# Town Council Meeting

**December 08, 2025 at 6:00 PM**

3. Consideration and Approval: **Hillside Groves Amenity Center - Final Site Plan Submittal**

4. Consideration and Approval: **Watermark - Final Subdivision Re-Submittal**

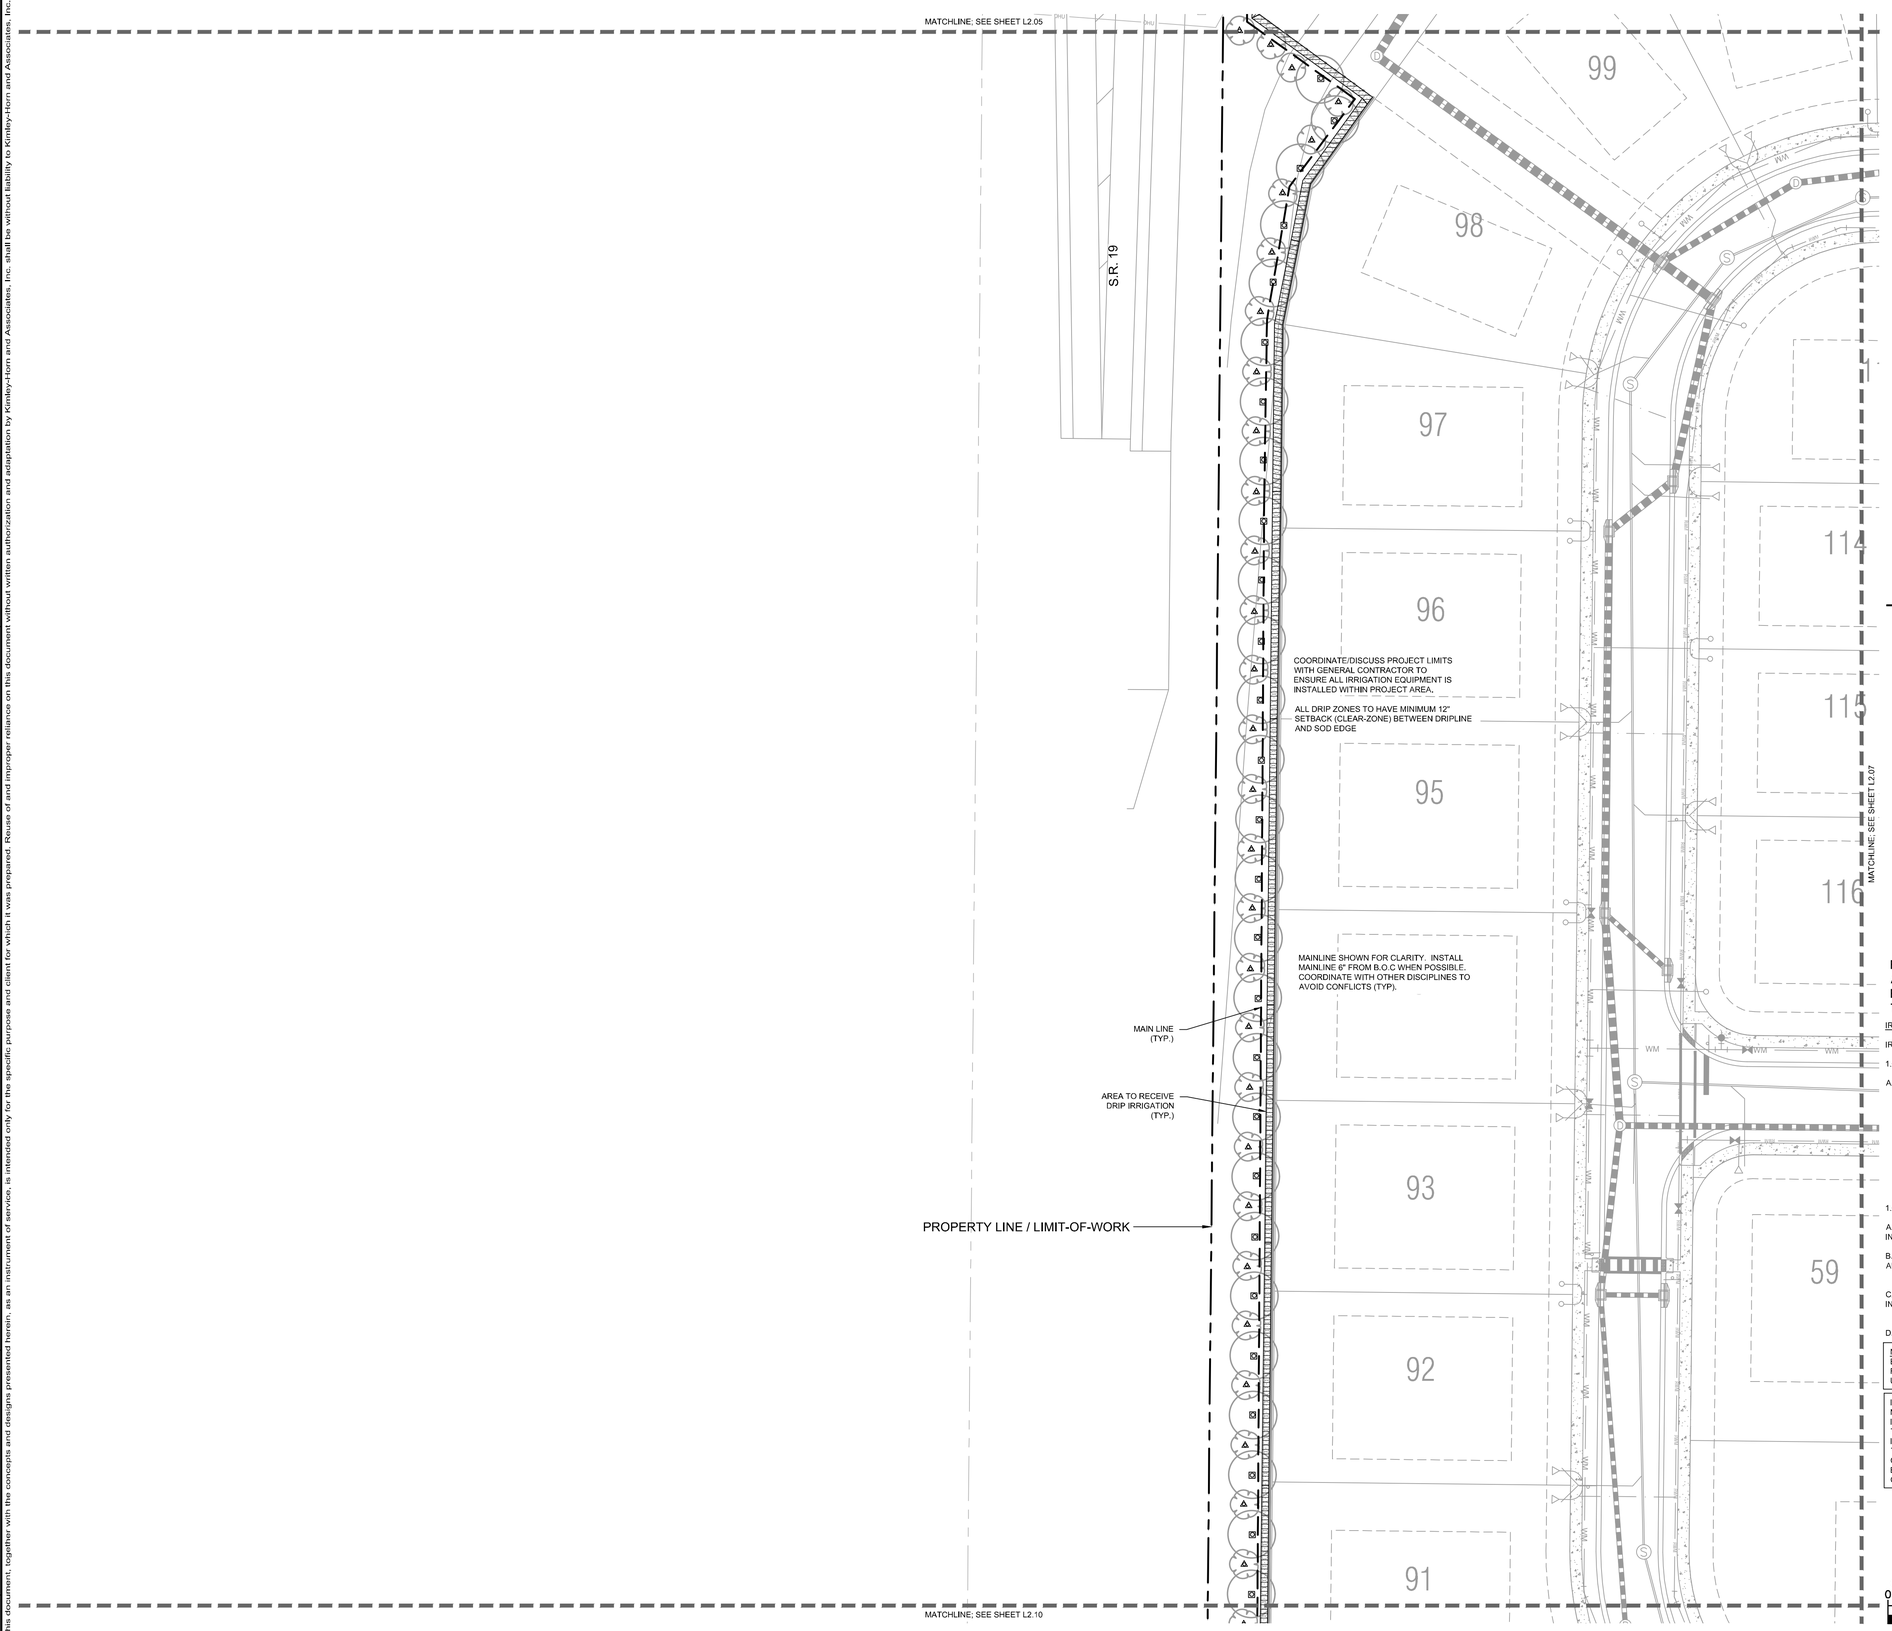
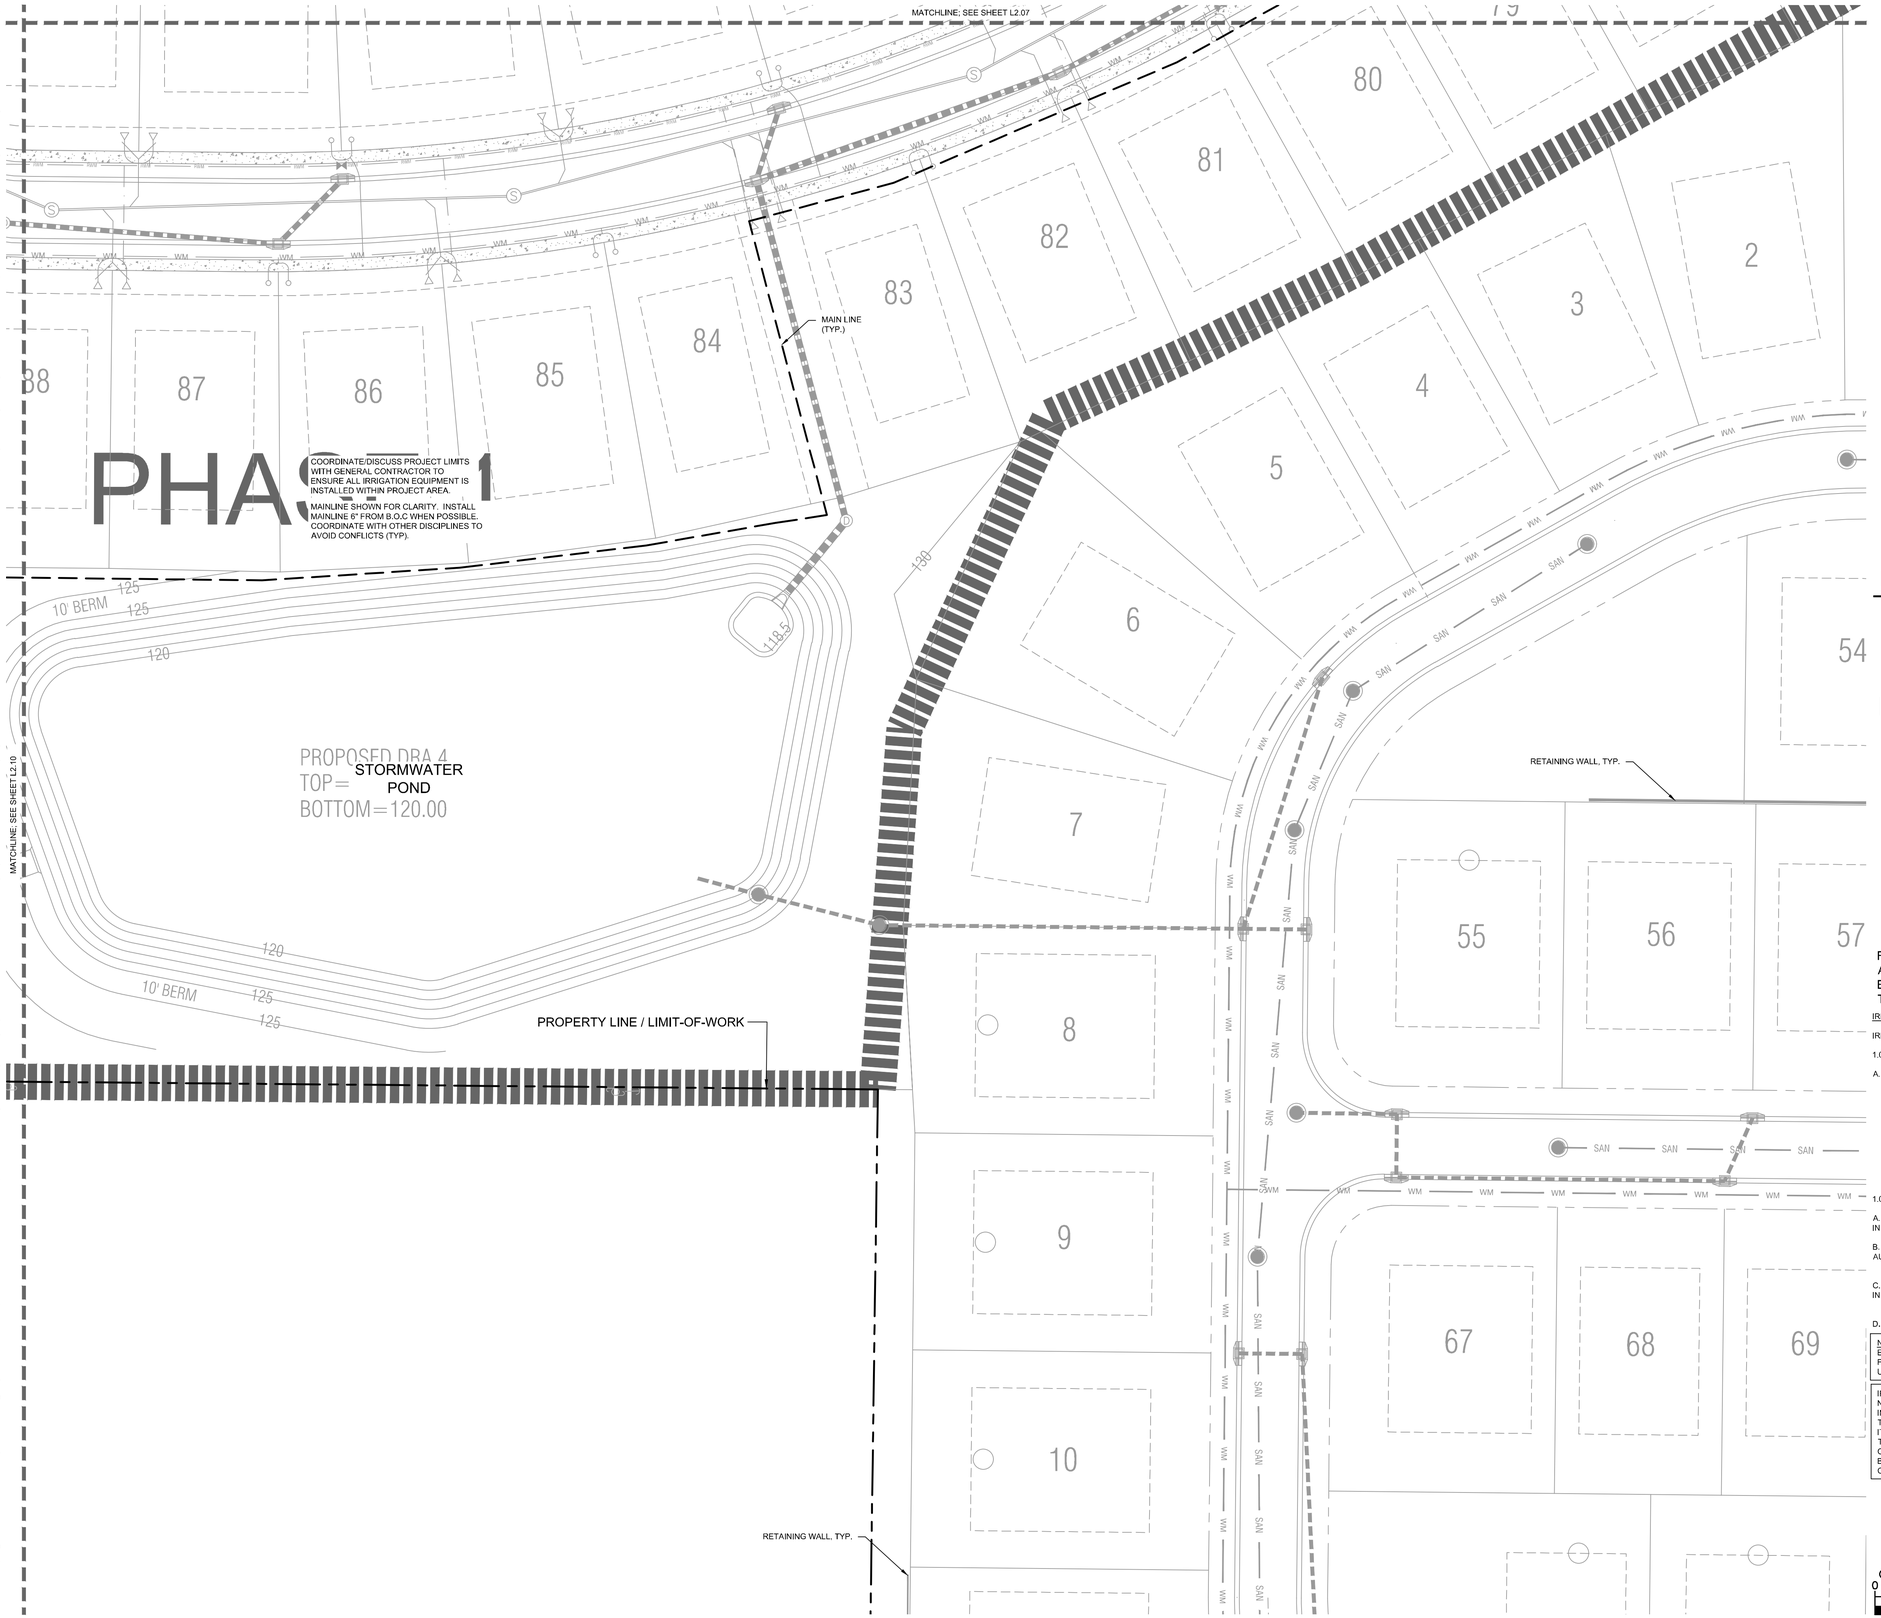
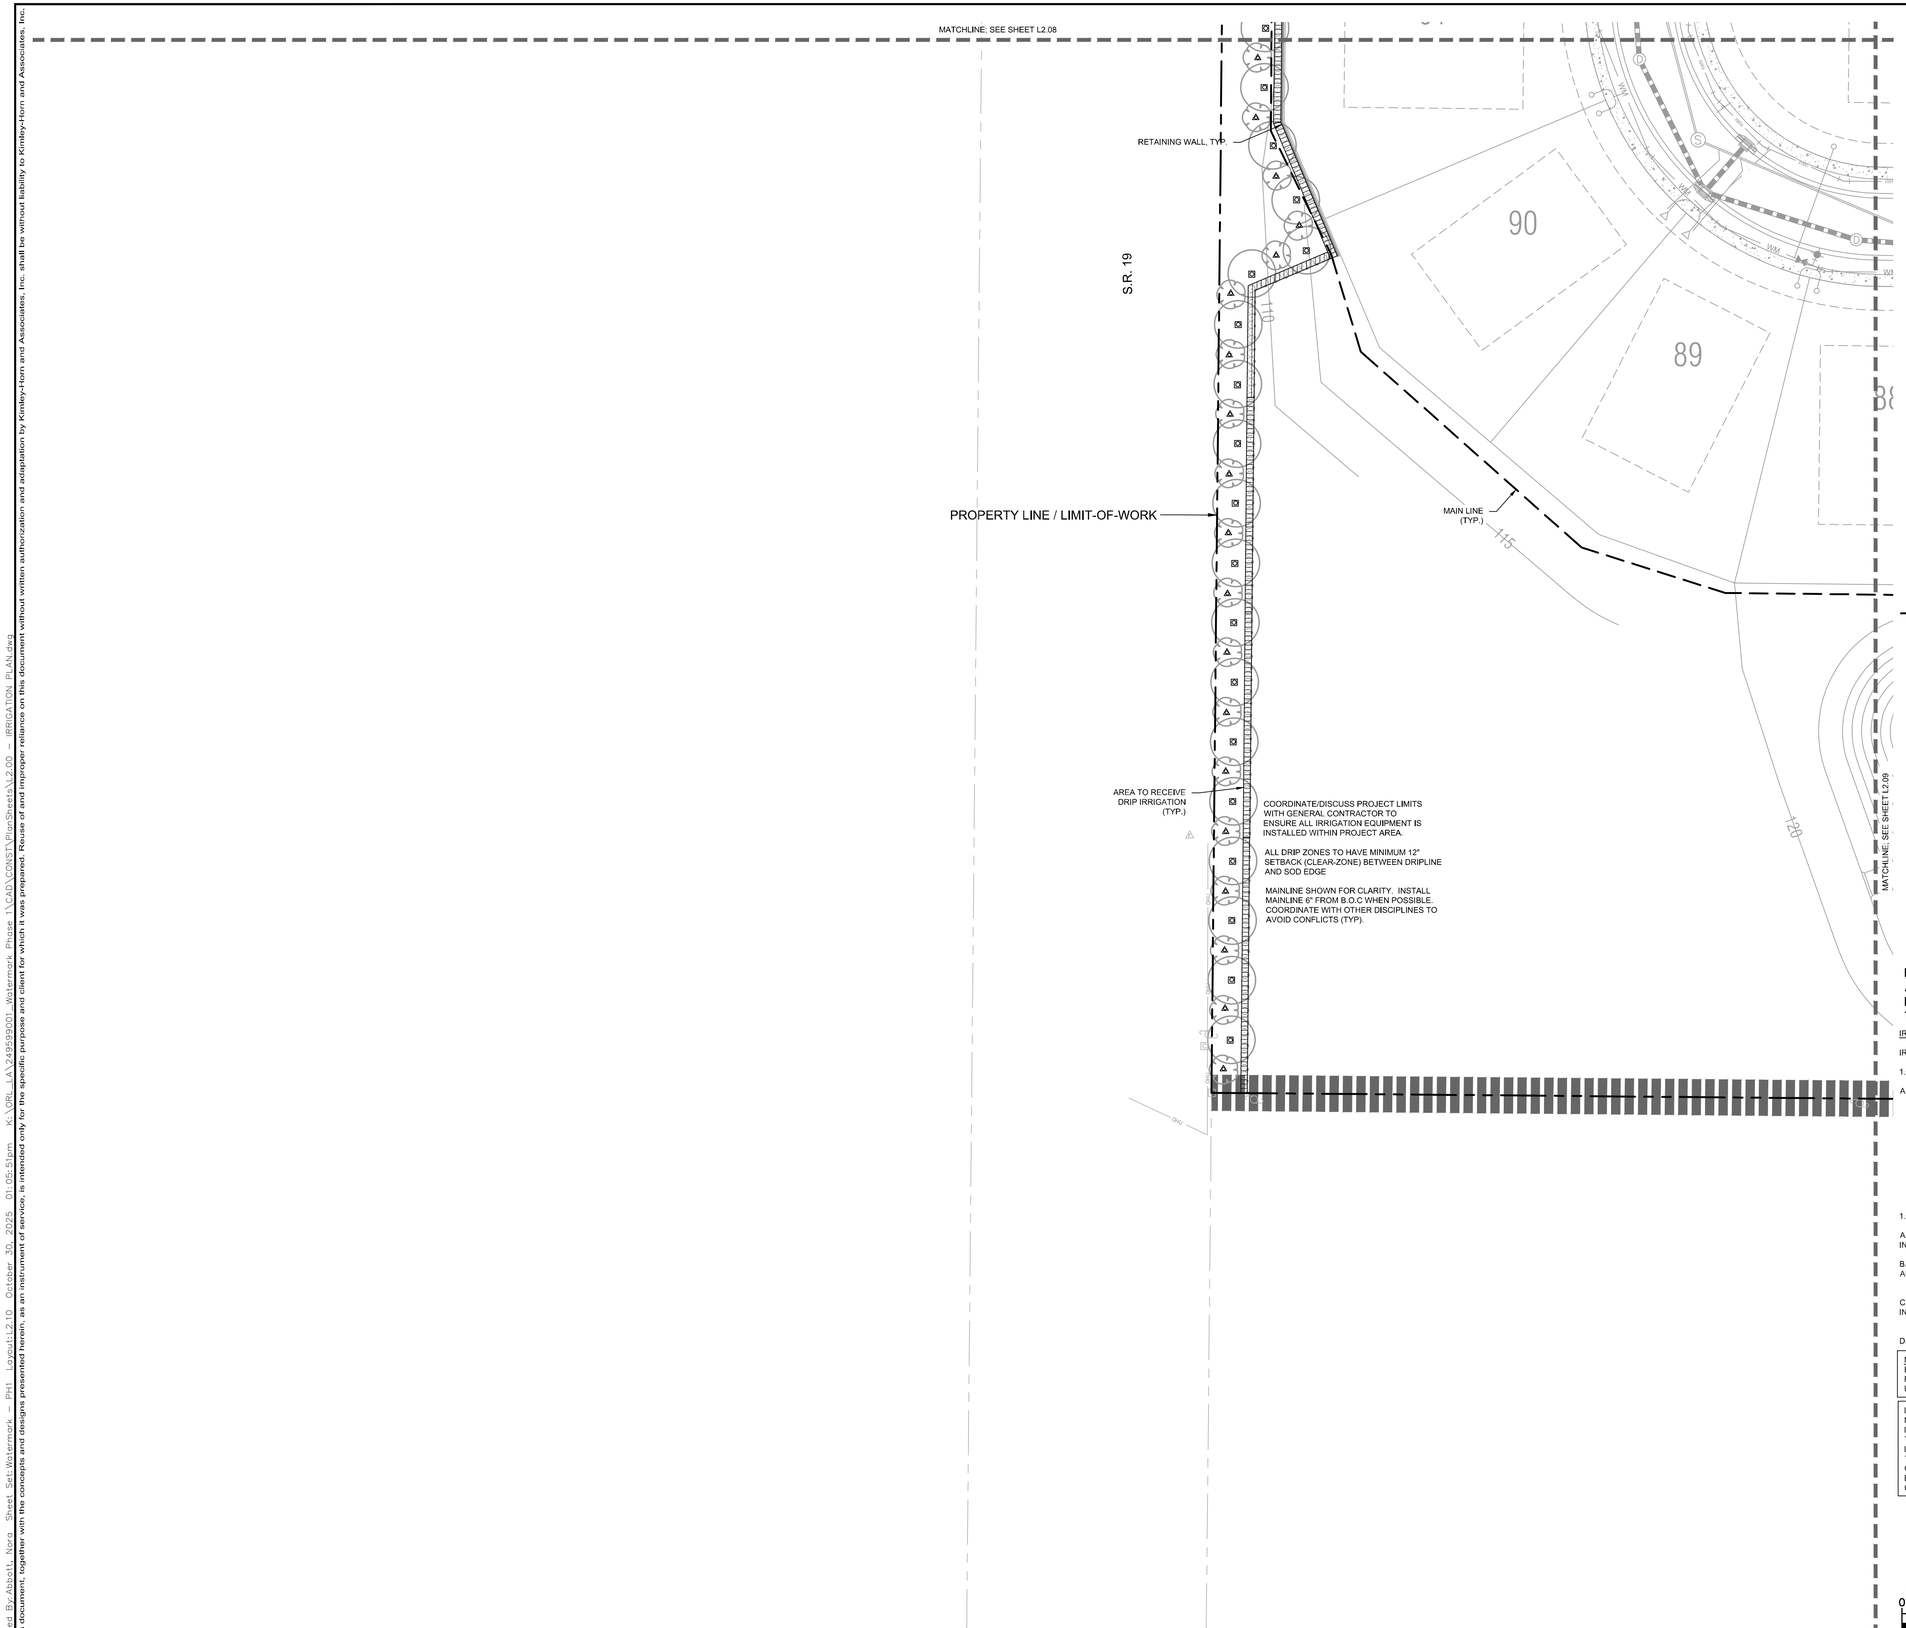
3. L1.08 through L1.10 and L2.08 through L2.10 need to be revised to show a wall per LDC requirements 7.02.01(B)(2) since these areas are not next to a stormwater pond.
